# Amendment Notice 2

**Licence Number** L8435/2010/3

**Licence Holder** GSM Mining Company

**Premises** Granny Smith Gold Mine  
Mining tenements M38/18, M38/361, M38/161, M38/162, M38/167, M38/191, M38/205, M38/287, M38/380, M38/389, M39/397, M38/440, M38/532, M38/525, M38/690, M38/691, M38/692, M38/725, L38/50, L38/51, L38/79, L38/80, L38/87, L38/96, L38/106, L38/144, L38/145, L38/144, L38/146 and L38/209

**Figure 2: Granny Smith Landfill Locations**

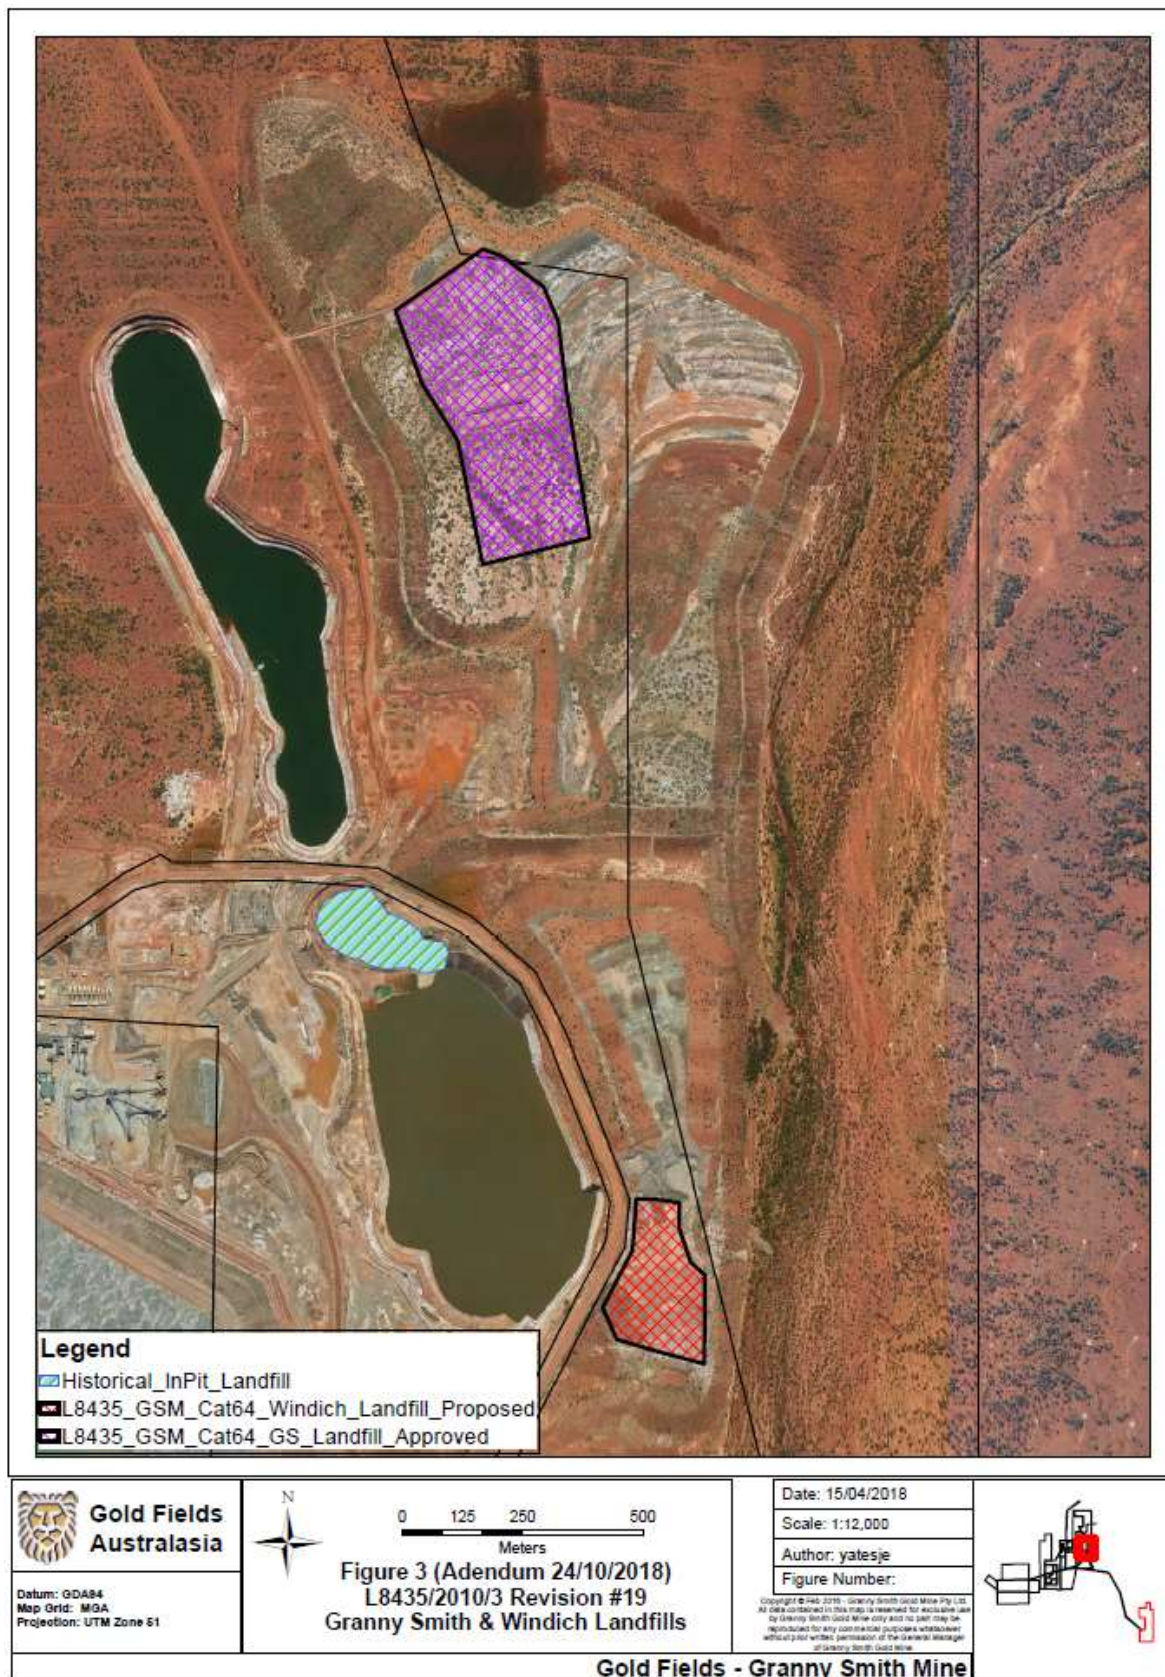
GSM has identified an on-site location which is currently used as a historical landfill for inert plastic and miscellaneous materials collected from the Granny Smith Plant trash screen. The location of the historic landfill is within the Granny Smith Pit which is no longer being mined and is currently full of water as a result of groundwater recharge, rainfall and some historical discharge from Wallaby dewatering in the early 2000s. The depth of the water is currently estimated at 100m. GSM confirmed the landfill has been active since the Granny Smith Processing Plant was commissioned in the late 1980's -1990's. Whilst the Licence includes category 64 for a Class II or III putrescible landfill site, the location of this landfill is not specified within it. GSM would like the specific location to be added to the Licence. GSM propose the design capacity of Category 64 will increase to 10,000tpa upon addition of this inert landfill location.

The Licence Holder also proposes the addition of Windich N site as another potential landfill area to be used as a trial in accordance with the existing licence cat 64 conditions. The Windich site is sheltered from the wind and presents an opportunity to trial a drive in/ drive out design that may be safer and impose a lower risk of windblown rubbish than the Granny Smith Landfill.

Figure 2 below replaces the Premises Map in Schedule 1 of the Existing Licence. It identifies

the historical in-pit landfill GSM has identified, the existing Granny Smith Landfill, and the proposed siting for the Windich Landfill site.

The Delegated Officer has determined that the addition of the historical in-pit and Windich proposed landfill sites to the Licence do not significantly increase the risk profile. To accommodate the additional landfill locations, the Delegated Officer has increased the design capacity of category 64 from 9,500 to 10,000 tonnes per year. The additional sites will be managed under the Existing Licence conditions for category 64.

**Figure 3: Water transfer pond containment upgrade**

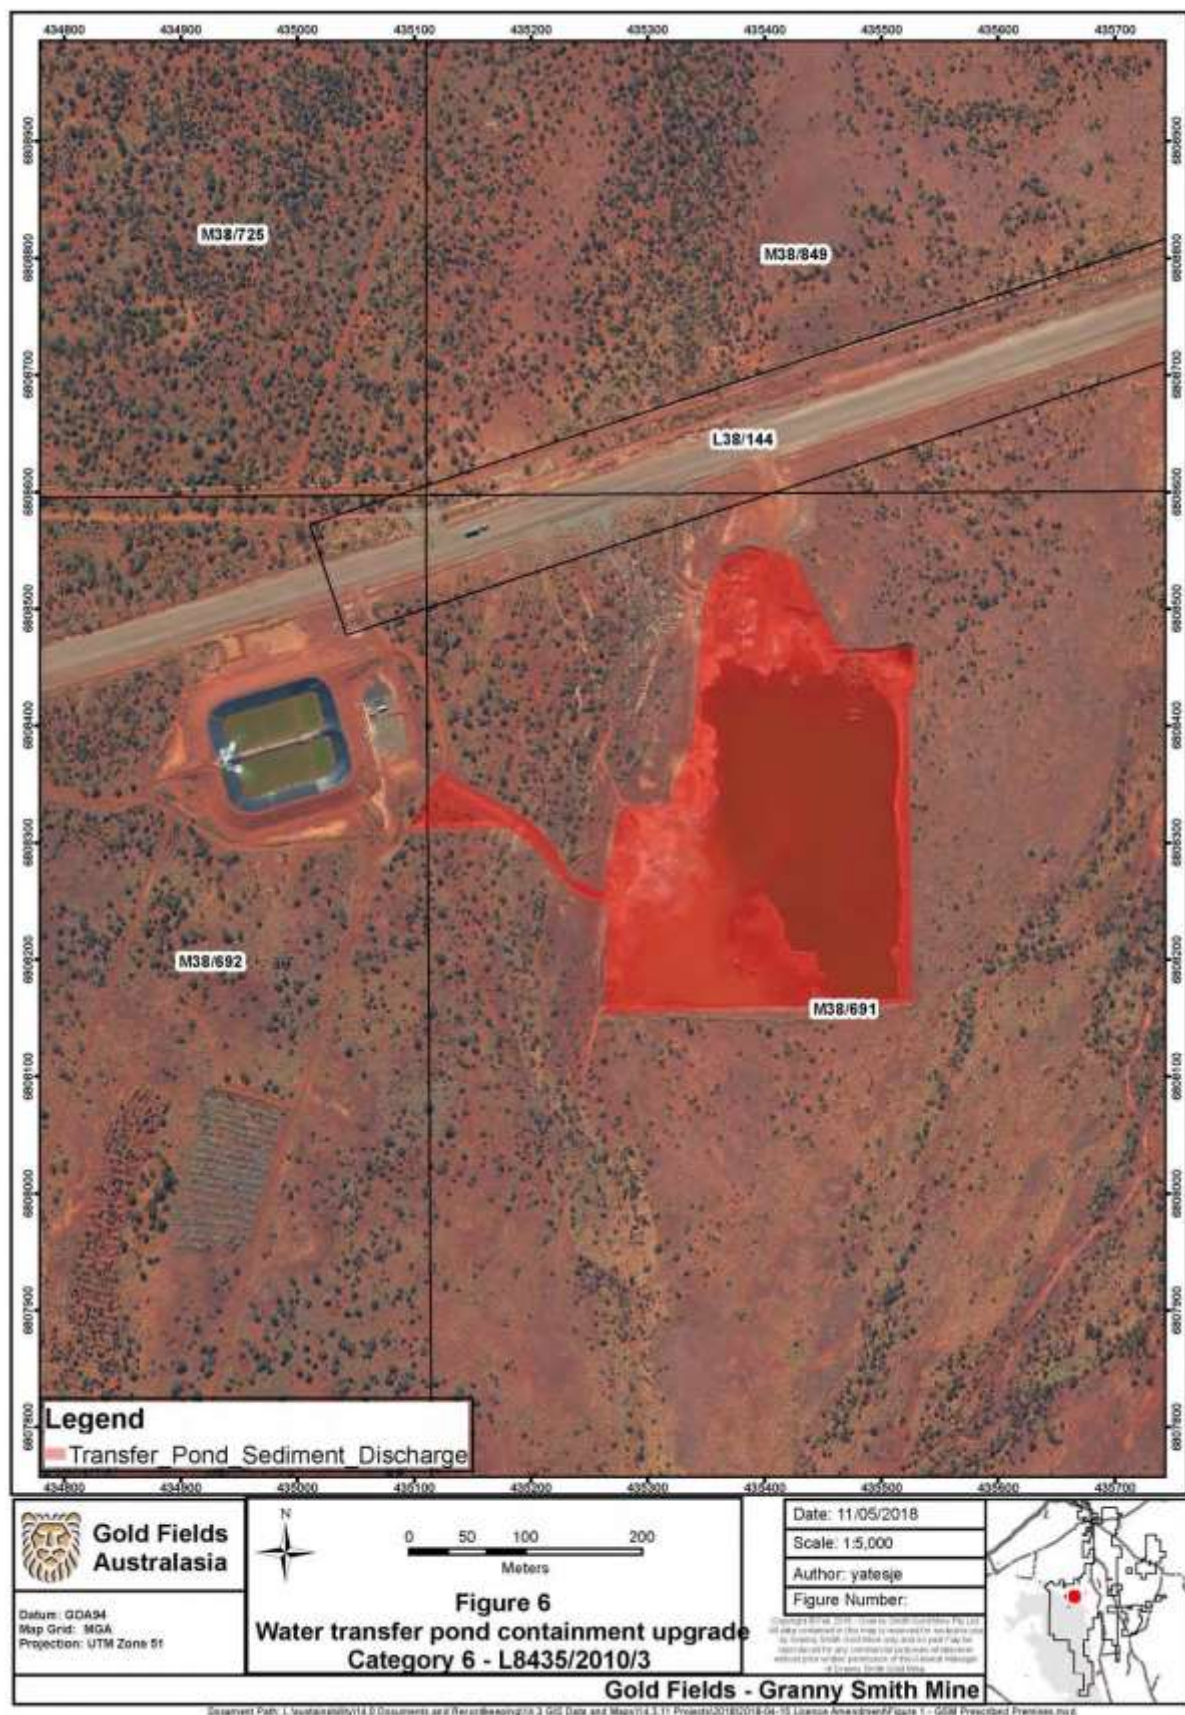
A twin cell sedimentation pond (transfer pond) currently captures and treats mine dewater prior to discharge to Lake Carey. As a result of the high levels of sediment in the water, a build-up occurs on the liner. As a part of the maintenance of the transfer pond, the sediment is required to be removed and discharged to a suitable location. GSM are proposing to utilise a borrow pit for the sediment build-up. The borrow pit is located directly adjacent to the Wallaby Dewatering southern discharge transfer sediment pond. It is approximately 2 m deep with sufficient capacity for periodic discharge from the transfer pond. Figure 3 indicates the water transfer pond containment upgrade. The site will be routinely rehabilitated in accordance with the GSM Mine Closure Plan at the time of closure.

The Delegated Officer has determined that the incorporation of the borrow pit as overflow for the water transfer pond poses low risk due to the low frequency of emergency discharge, and the Licence Holders proposed management methods. The Licence Holders controls will be conditioned into the Licence.

## Map of WAP Overflow Area

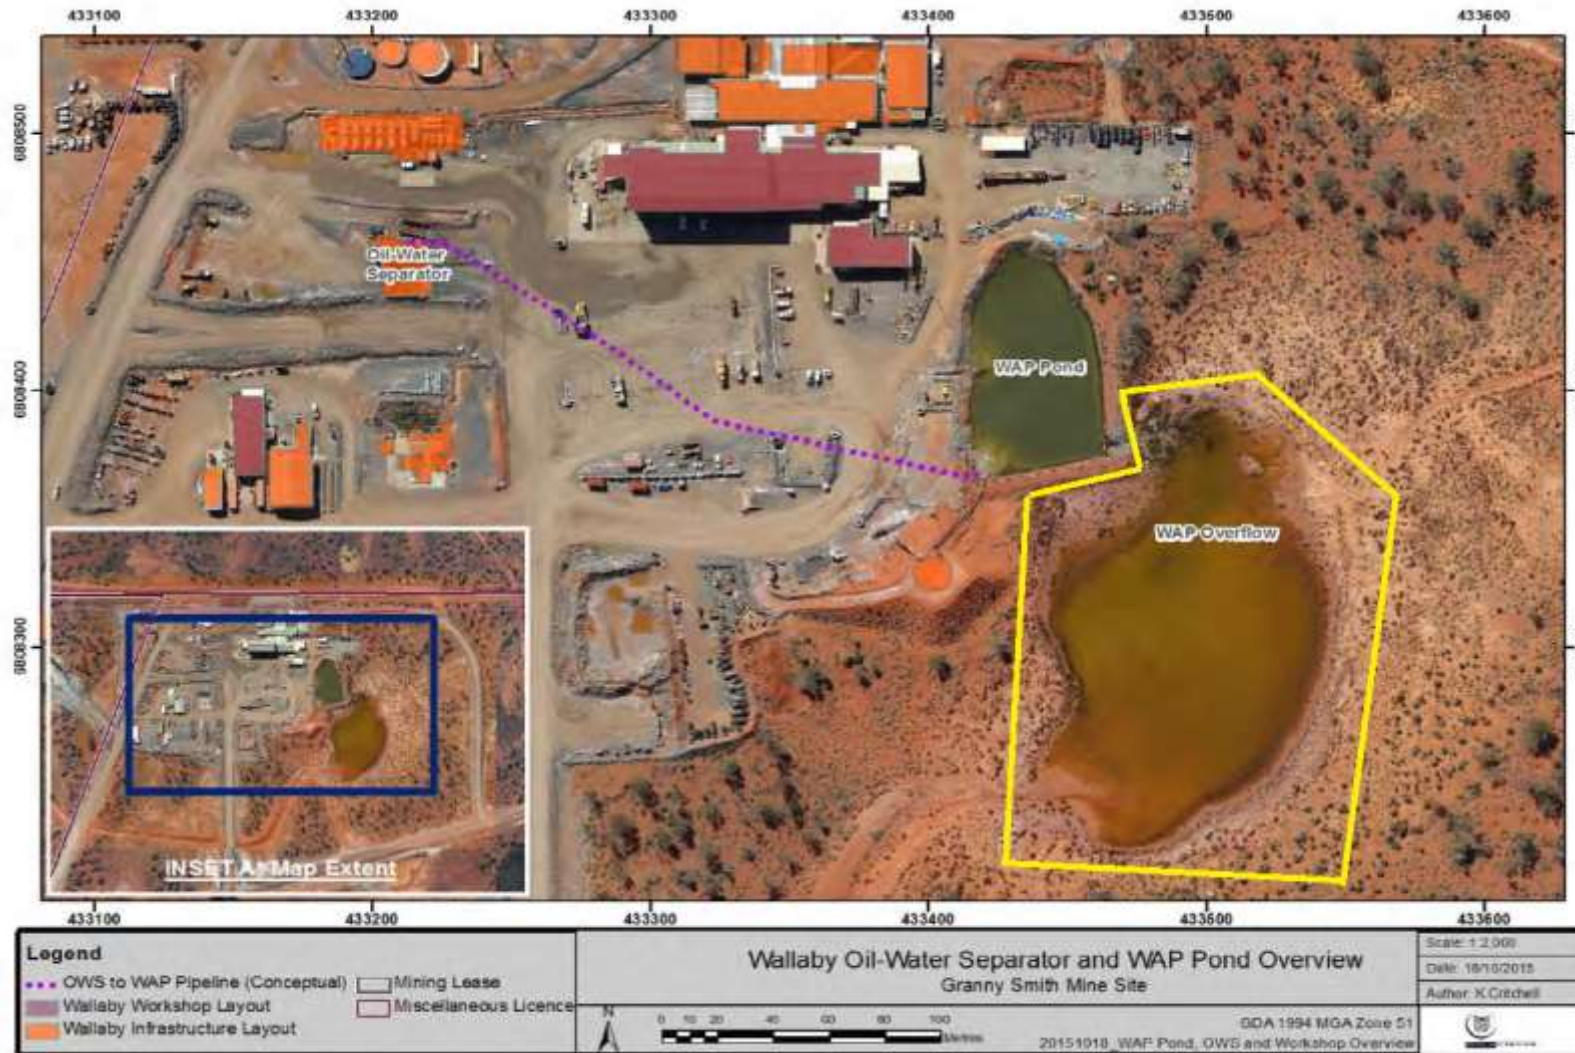
12. Schedule 1 of the Licence is amended by the insertion of the map shown over.

The boundary of the WAP overflow area as defined in Condition 1.2.15 is shown in yellow below

1.2.15 The Licence Holder shall ensure that discharge of wastewater from the WAP overflow area (as shown in Schedule 1) does not occur.
